Zoning Board of Appeals Staff Report

SUBJECT: ZBA 23-006

**PROJECT
SITE:** 9155 Riverside Drive
TID 15-24-102-099

PROJECT: Variance application to permit the construction of a two-story addition to an existing dwelling. The addition will have a 5.25-foot south side yard setback (10-foot south side yard setback required, Section 36-186).

9155 RIVERSIDE DRIVE
 LOT 14 ORE LAKE LITTLE FARMS SUB
 EXISTING CONDITIONS SURVEY PLAN
 ACE CIVIL ENGINEERING

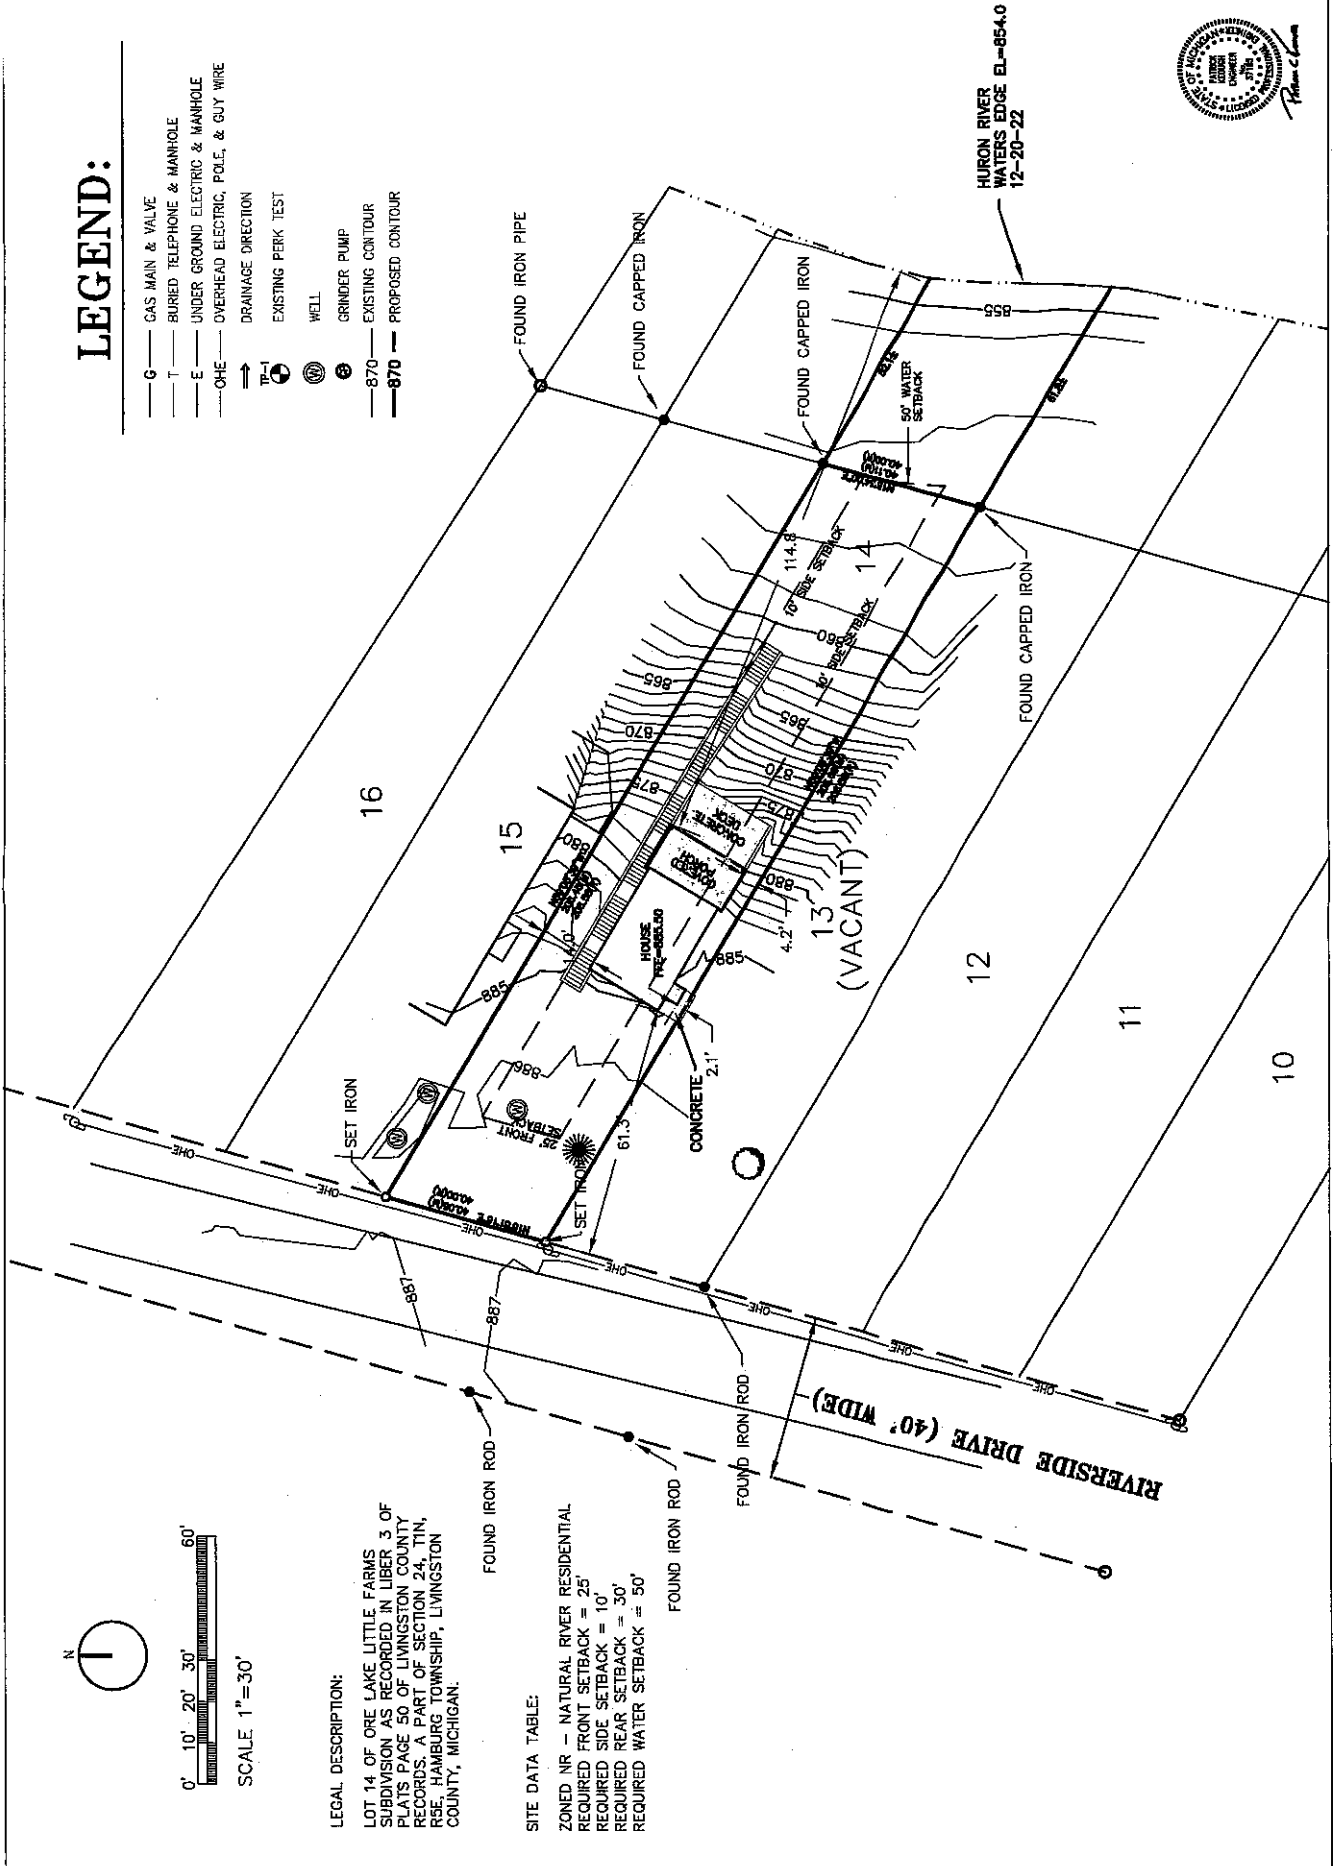
Good morning – I am writing in regards to the application for a Zoning Board of Appeals review for the property located at 9155 Riverside Dive (Parcel #15-24-102-099) for James & Suzanne Purdy. It is unclear if your plans are to rehab the existing home or to look to see if it can be rehabbed or if necessary demolished and building a new home on the lot. If the existing home is demolished and a new home is constructed on the lot the owners will be required under Township Ordinance to connect to the Hamburg Township Sanitary Sewer System (HTSSS). This would be a mandatory sewer connection and could not be waived. If you plan to try to rehab the structure you may also be required to connect to the sewer system if the on-site septic is inadequate or has failed or is failing. In that case the Township Ordinance requires the property to be connected to the sewer system. Repairing or replacing the on-site septic system would not be allowed.

In either case, the Application for Sewer Connection would need to be submitted to the Township along with a site plan showing the location of the house on the property with the current well and septic locations, and a non-refundable application fee of \$200.00. The Township staff would then work with the property owners to determine the best location to install the grinder pump station for the sewer connection and develop the estimate of cost for the sewer hook-up. The estimated sewer connection fees must be paid in full prior to the issuance on the Land Use Permit (LUP) to rehab or rebuild the house on the lot.

SITE PLAN
 SCALE 1"=30'

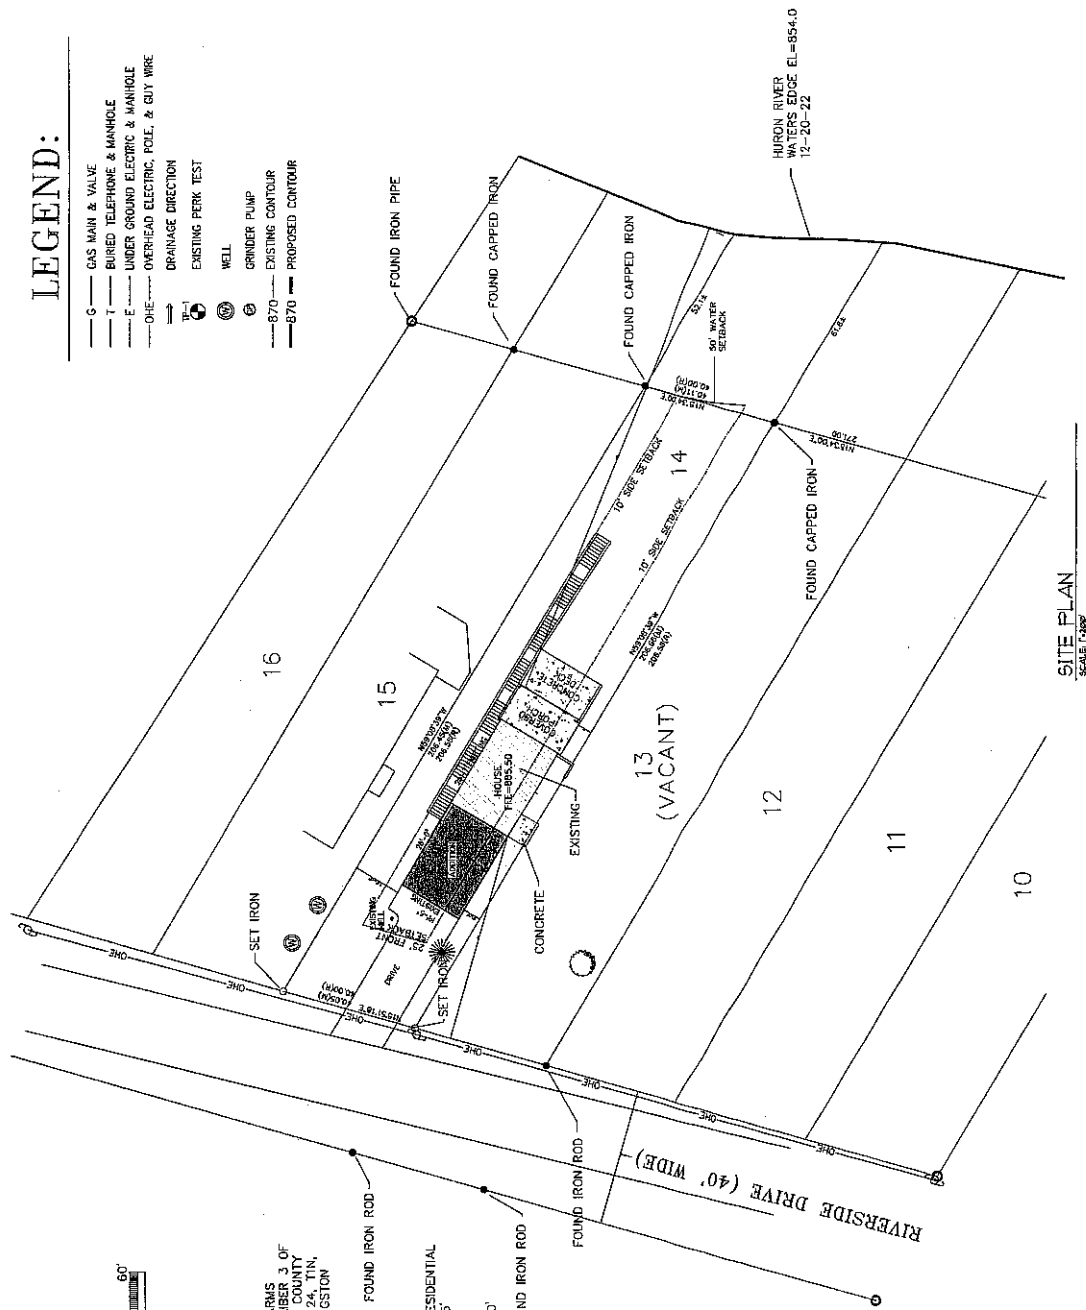
If approved, the variance would permit the construction of a two-story addition to an existing dwelling on the west front facade. The addition would have a 5.25-foot south side yard setback (10-foot south side yard setback required, Section 36-186).

A site similarly sized in the waterfront residential district could make use of reduced side yard setbacks of five and ten feet. The reduced setback provisions do not apply to the NR districts. Maintaining 10-foot side yard setbacks would result in a 20-foot wide building envelope. While the township no longer has a minimum dwelling size, staff believes that a narrow lot such as this in the NR district deserves some relief from the 10-foot side yard setback requirement.

The applicant is proposing a reasonably sized addition, whether the intent is to add to the front of the house or remove the existing structure and rebuild with the same setbacks. Given that the site is 40 feet wide, maintaining 10-foot setbacks would leave a 20-foot wide building envelope. Staff does not find that the modest addition within the setback would be materially detrimental to the public welfare or materially injurious to adjacent properties. It appears that it will be consistent with the manner in which adjacent lots have developed.
